MEMORANDUM

From: Stephen Chiles, Chiles Ltd
To: Pam Butler, KiwiRail
Date: 12 February 2021
Subject: KiwiRail Regional Freight Hub -
Response to requests for information relating to noise and vibration

Palmerston North City Council has requested further information relating to KiwiRail's Notice of Requirement for the proposed Regional Freight Hub (PNCC letter dated 14 December 2020). Items 7 to 31 of the request for information relate to noise and vibration. Responses to those items are provided in this memo. For each item the request is written in italics followed by the response. Several responses refer to a set of 17 figures that are attached to this memo.

Project: Central North Island Freight Hub
 Client: KiwiRail
 Title: Figure 4
 Indicative operational noise with noise barriers (Technical Report D Figure 12)
 Drawn: MS
 Date: 26 Jan 2021

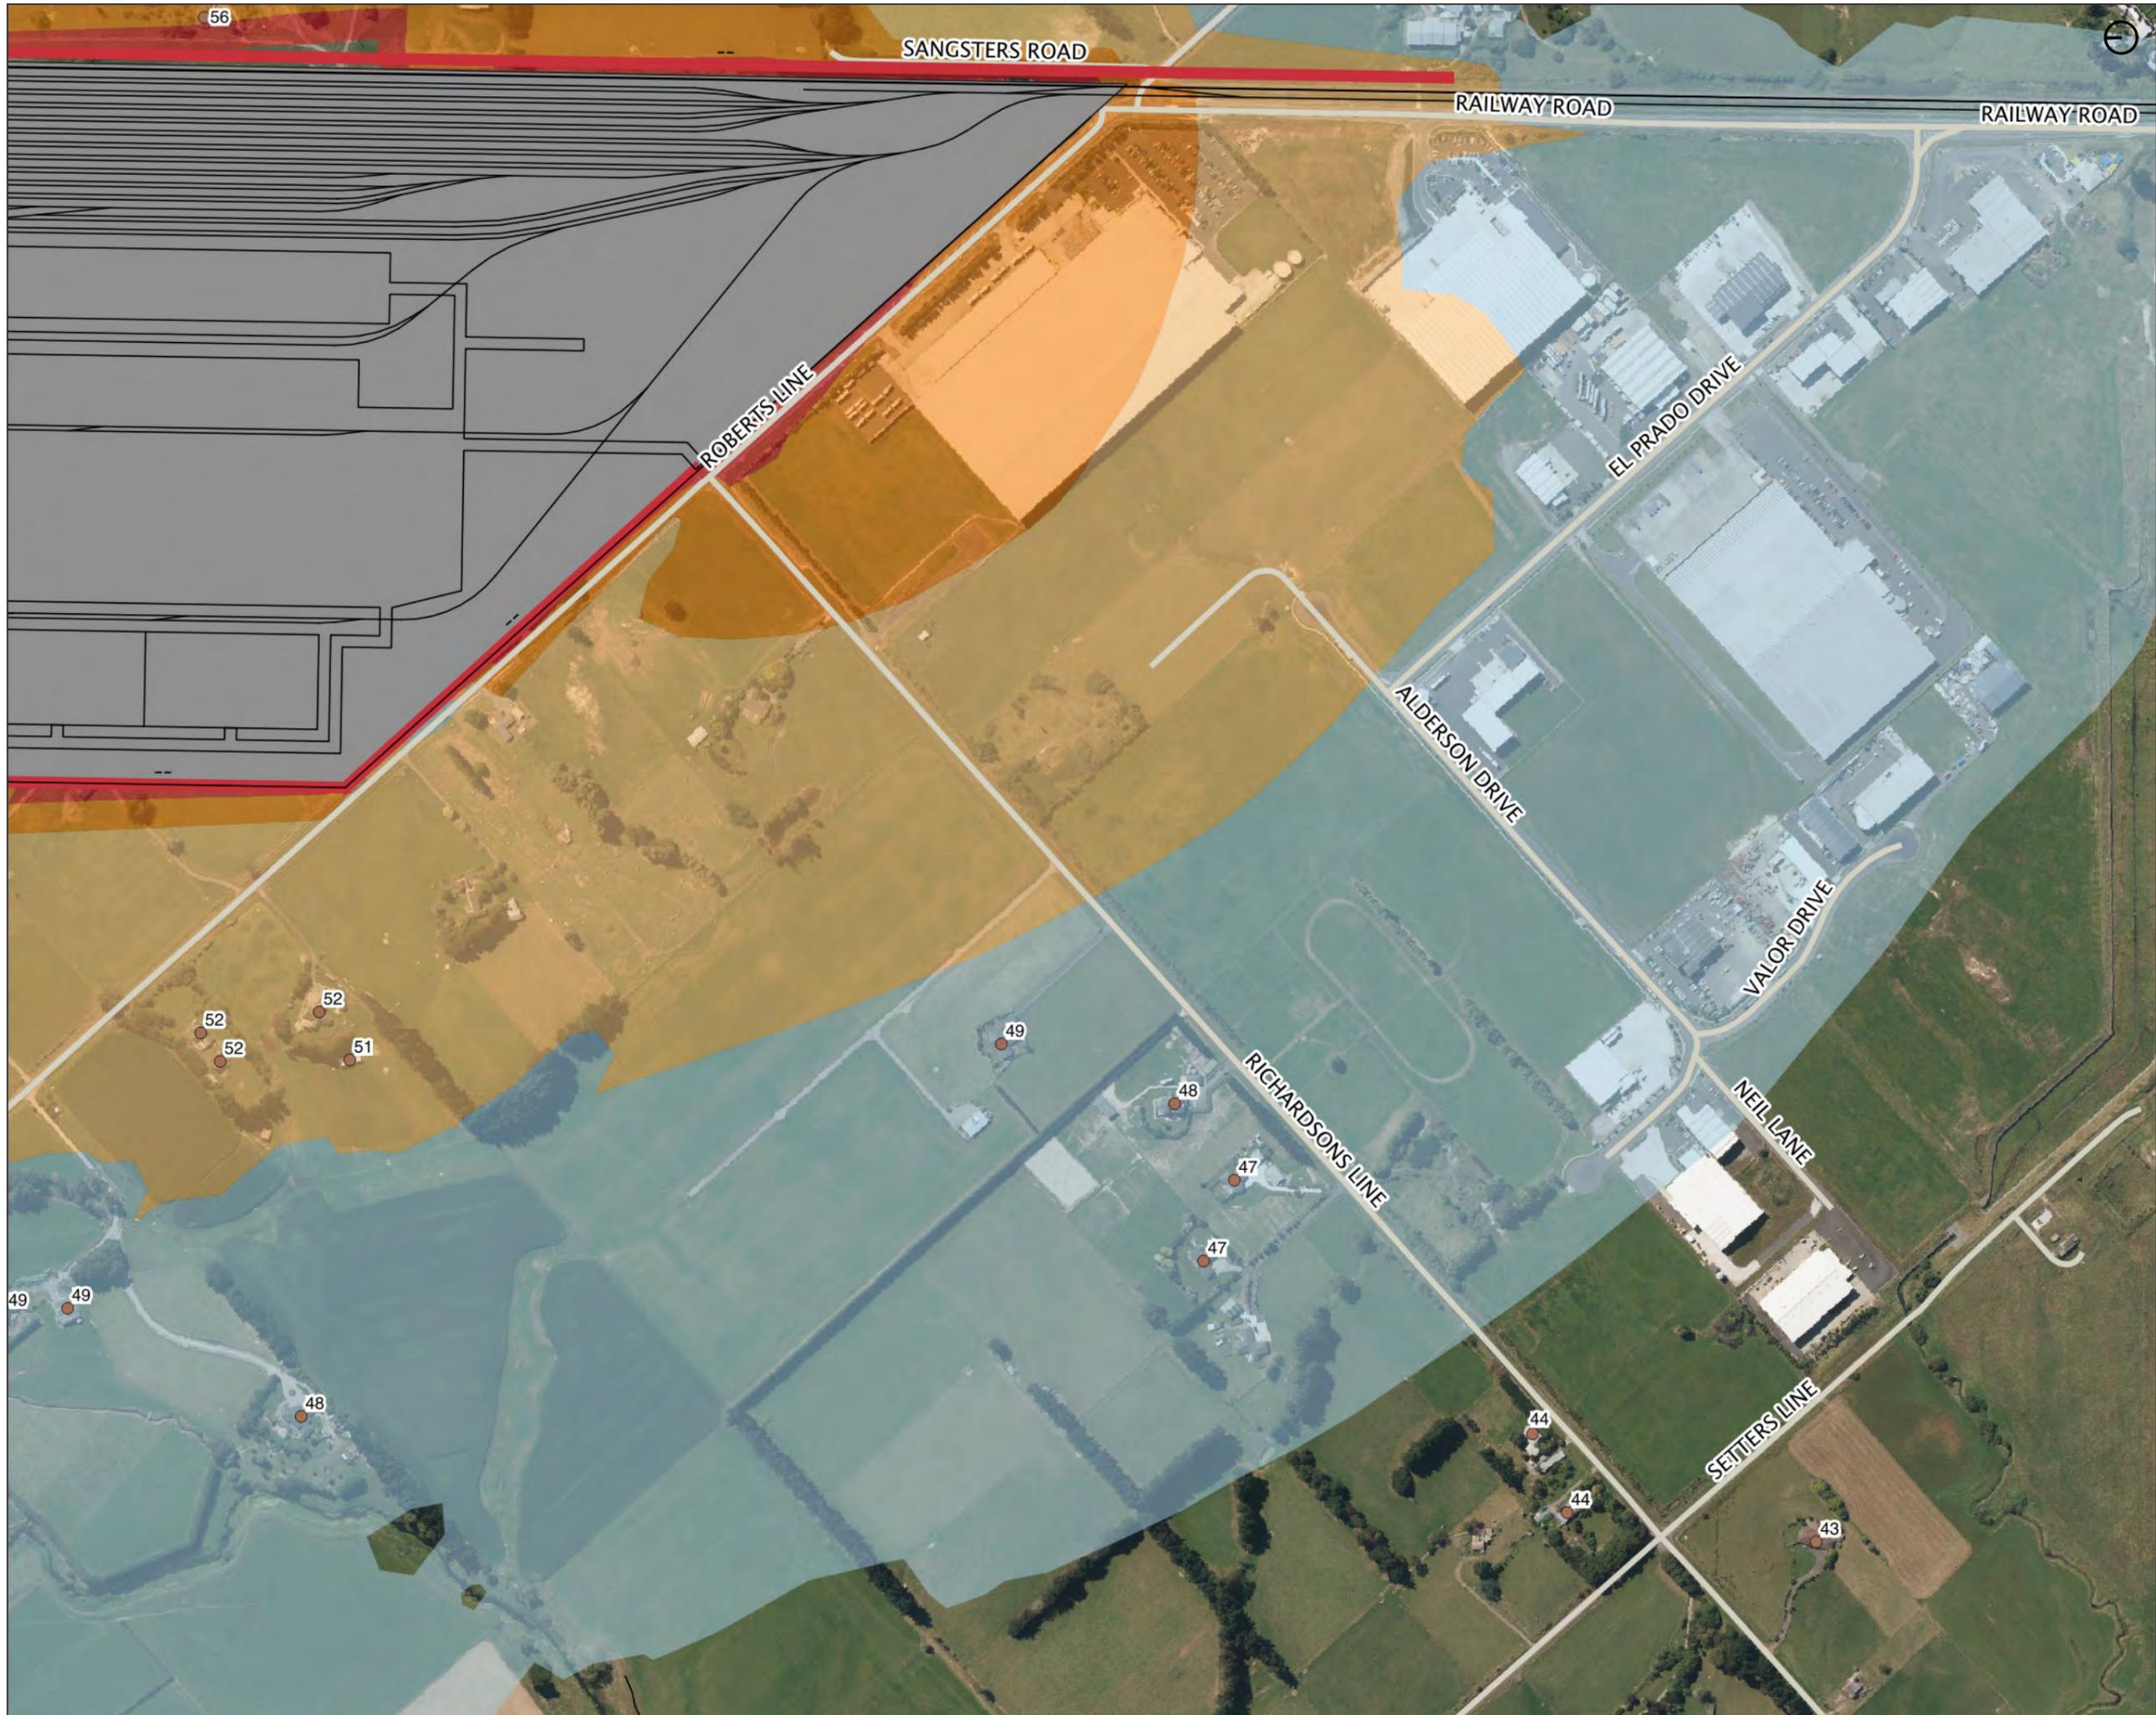
With respect to 8 & 9 above please provide daytime noise management boundaries predicted at 5 dB increments between 70 dB LAeq (1hr) and 50 dB LAeq (1hr).

Please provide the predicted noise levels for individual dwellings or representative groups of dwellings with the predicted levels for the various scenarios (i.e. for the different screen heights). Sites on which dwellings can be constructed as a permitted activity and commercial buildings also need to be identified.

The spatial distribution of other indicative LAeq(1h) noise contours is shown in Technical Report D Figure 12 (page 38). To aid reading of this figure the data has been reproduced at a larger scale and is attached as Figures 2 to 7. The range of noise contours shown is from 65 dB to 45 dB. Beyond this range contours are either within the site or extend over too great a distance for meaningful predictions.

To aid reading of Technical Report D Figure 12 (page 38) the data for the scenario with noise barriers has been reproduced at a larger scale in the attached Figures 2 to 7. The indicative sound level has been annotated on each building that has been assumed to be a house. At this stage houses near the site have been identified from inspection of aerial photographs.

Project: Central North Island Freight Hub
 Client: KiwiRail
 Title: Figure 9
 Comparison of east mitigation options
 Date: 27 Jan 2021
 Drawn: MS

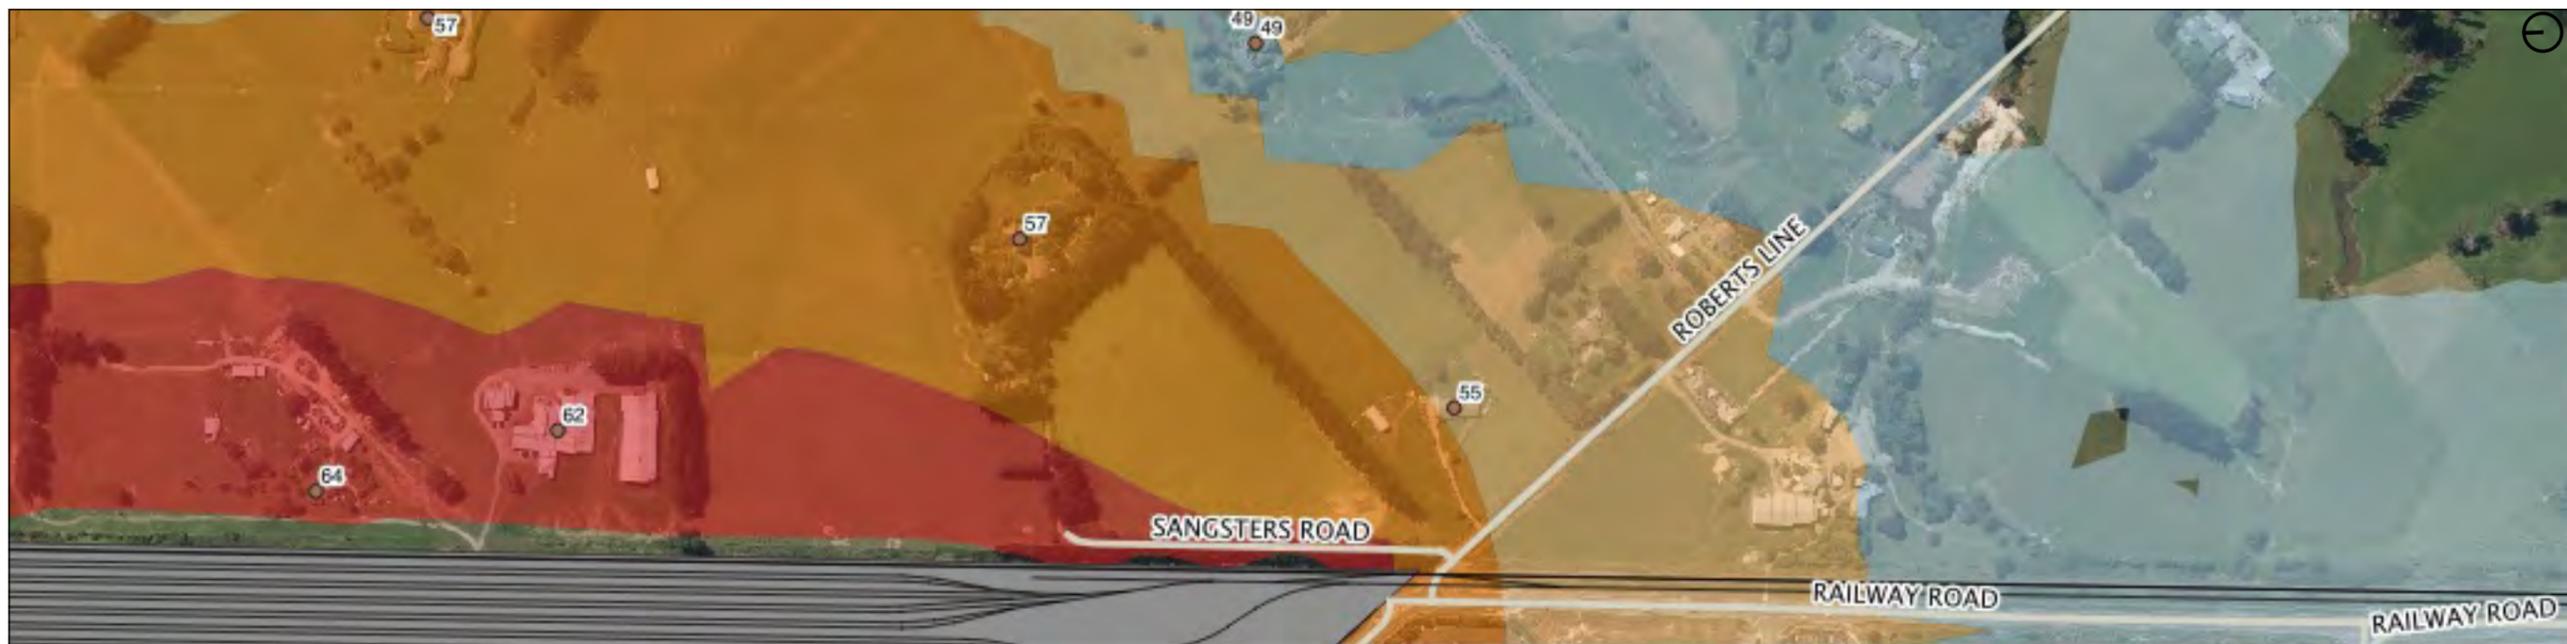
Given the different character of effects associated with the mitigation measure, please provide additional modelling of the acoustic screen height for daytime and night-time activity levels at the following height scenarios: (i) no bund or barrier; (ii) 3 m screen; (iii) 5 m screen.

For the east boundary Technical Report D has figures showing noise levels with no barriers (Figure 9, page 29) and 5m high barriers above the Freight Hub (Figure 12, page 38). Modelling has also been conducted to evaluate other height barriers including 3m high barriers. That model for a 3m high barrier has been updated to use the same site layout and assumptions as shown in Technical Report D Figures 9 and 12. Based on this information a comparison of sound levels with no barriers, 3m high

barriers and 5m high barriers on the east boundary is shown in the attached Figures 8 to 10. For other site boundaries indicative barriers modelled in Technical Report D Figure 12 are conventional heights (up to 3m high) so a similar comparison is not necessary.

Project: Central North Island Freight Hub
 Client: KiwiRail
 Title: Figure 11
 East Noise Wall Cross Sections

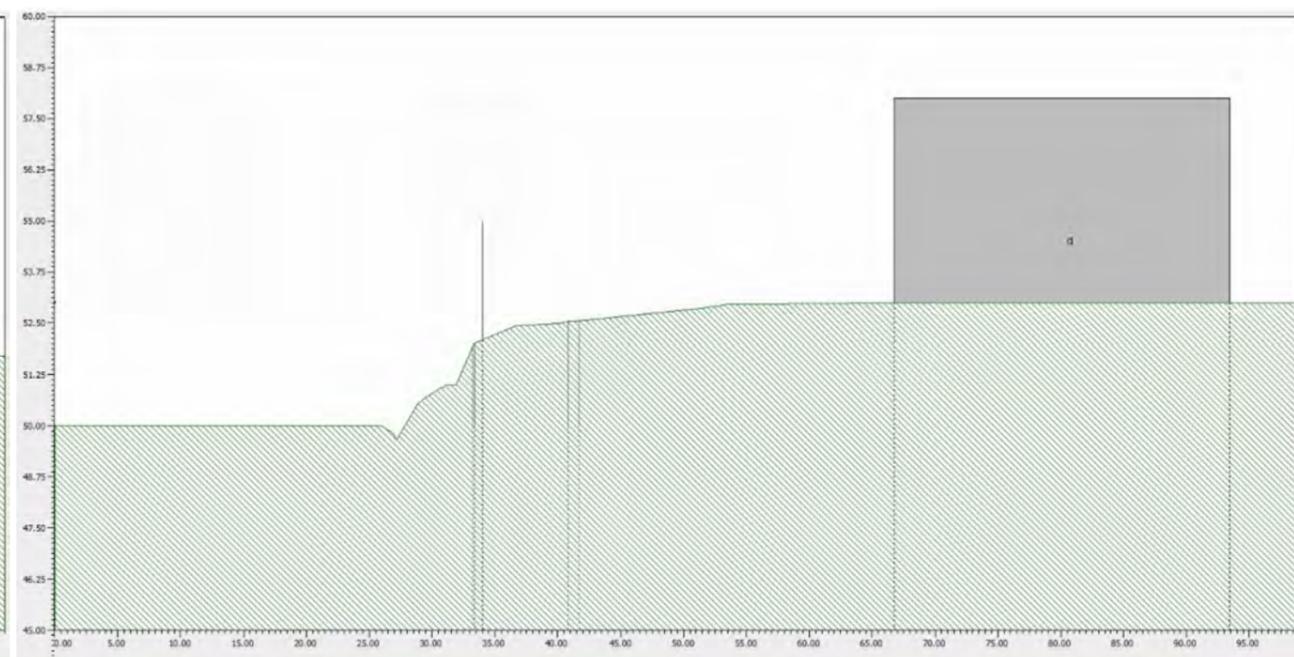
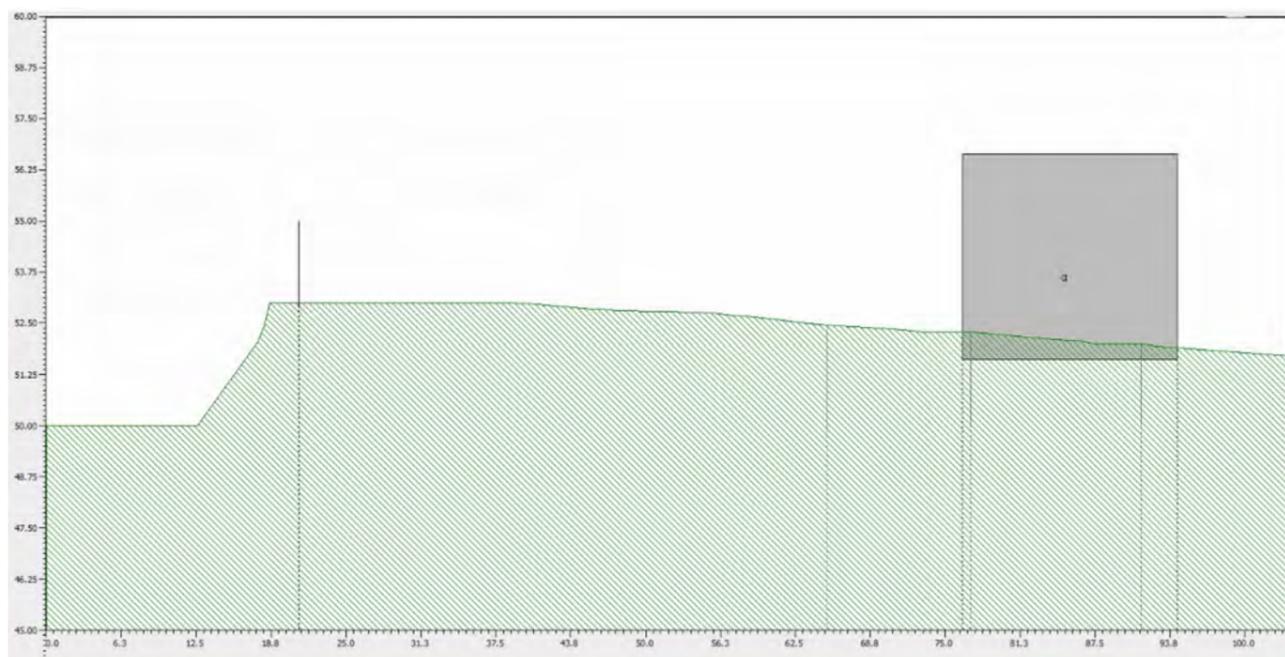
The height of the acoustic screen is taken from the Regional Freight Hub side. Please provide additional sections through the high points on Sangsters Road, e.g. 27 & 91 Sangsters Road.

Cross sections through the acoustics model are provided in the attached Figure 11. The horizontal alignment of the barrier top will vary to integrate with the engineering and landscape design, and that developed terrain contours have not been included. These cross sections are only relevant for acoustics modelling.
